V2500 Propulsion System - Nacelle

SERVICE BULLETIN

Subject: Transmittal of Revision 1 Service Bulletin Number V2500-NAC-71-02

SUBJECT: NOSE COWL - REPLACEMENT OF LIPSKIN ATTACH RIVETS

Nose Cowl Rivet Replacement
Figure 1

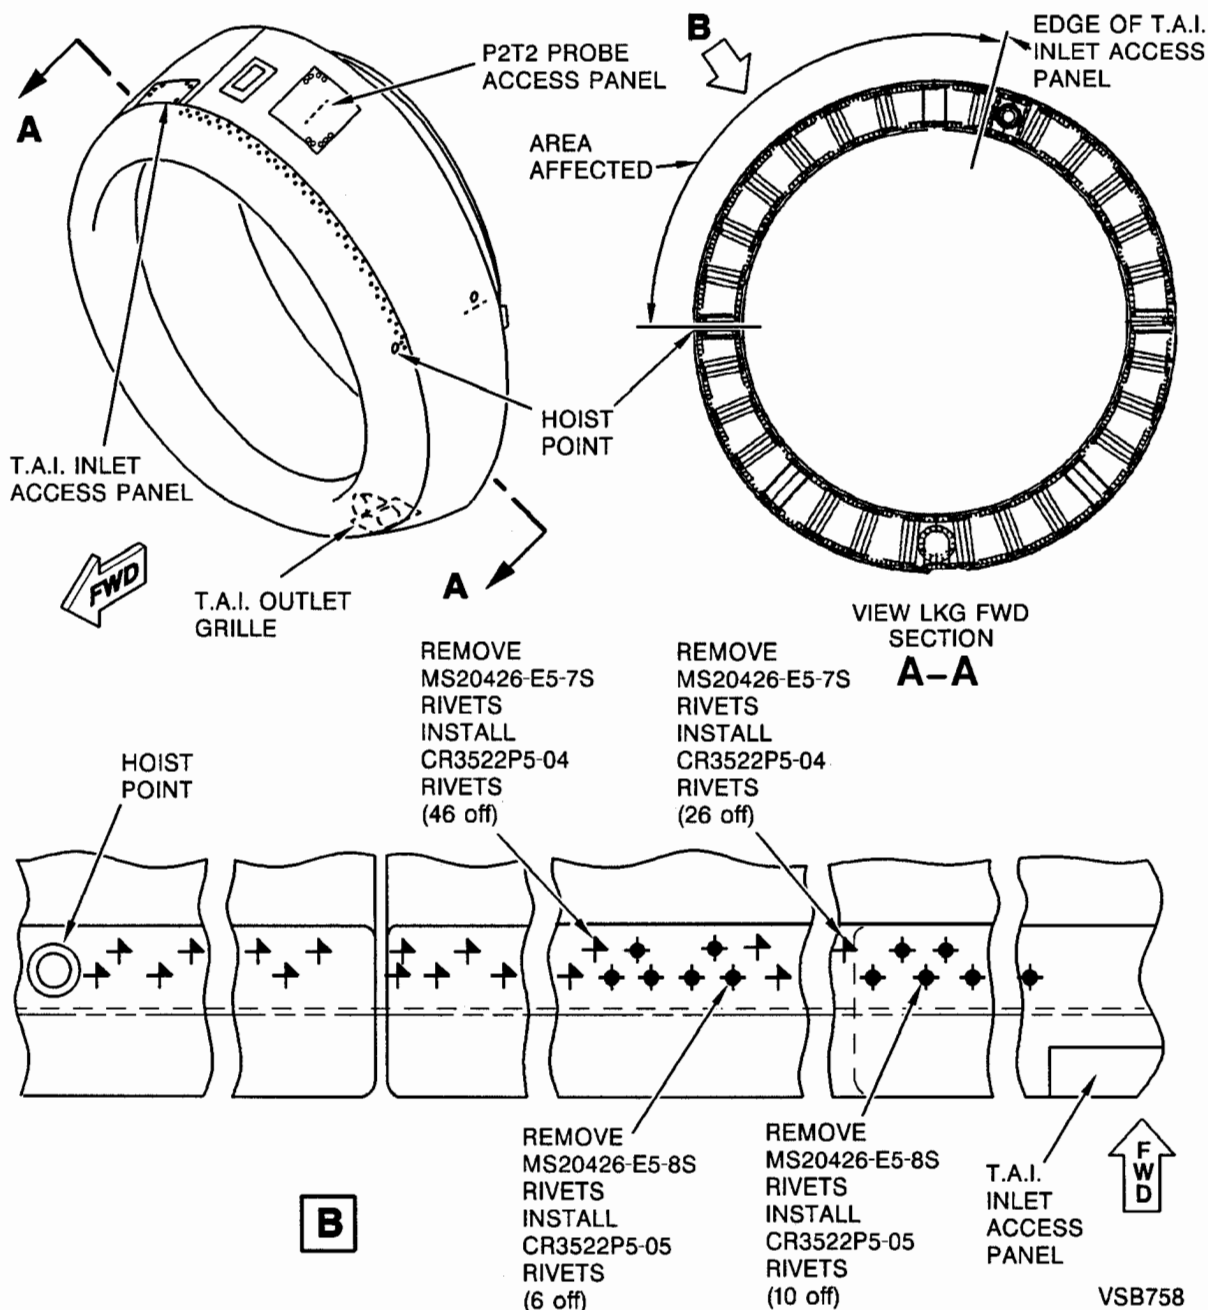
- (1) To revise the lengths of the rivets required for accomplishment and delete the service bulletin kit.

B. Replace the nose cowl lipskin attach rivets. Refer to Figure 1.

- (1) Remove the 88 existing lip skin attach rivets between the edge of the T.A.I inlet access panel and the first hoist point. Do not remove all of the rivets at the same time. Refer to Figure 1. Do not damage the rivet holes.
- (2) Examine the rivet holes. Make any damaged holes larger. Refer to Figure 2 for oversize limits. Countersink the holes that you make larger 100 degrees.
- (3) Remove the rivet and drilling pieces from the nose cowl. Remove and install access panels as necessary.

(7) Wet install the rivets with primer mix. Refer to Figure 1.
